## MEMORANDUM

**File No.:** DRV18-00493

**Subject:** **ROSE HILL MIXED USE PROJECT CONCEPTUAL MASTER PLAN AND PROJECT DESIGN RESPONSE CONFERENCE**

**Design Response Conference**  
Submittal #2 - DRV18-00493  
December 3, 2018

**8** BUILDING D - SW ELEVATION AT U-HAUL

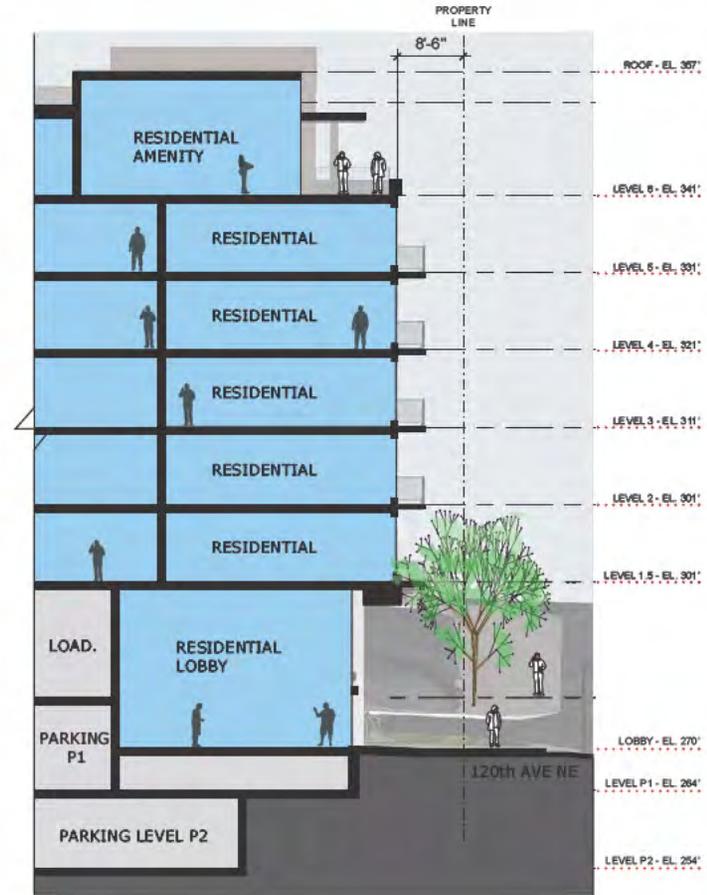
- The upper level treatment of Building D along NE 85<sup>th</sup> Street façade.
- Treatment of Building D façade near the U-Haul site.
- Larger scale elevations of each building to help with building by building review.
- Generic material details and treatments for each building.
- Additional parapet and roofline modulation.
- Onsite light study for courtyard and open space areas.
- Planter wall details and design for entry terrace.
- Design of loading dock along 122<sup>nd</sup> Avenue NE.
- Incorporate impacts of the U-Haul easement on the frontage and building design.

The applicant has submitted revised plans to address these items (see Attachment 2). Additionally the applicant has revised the plans to eliminate the health club space in Building A and replace it with residential units.
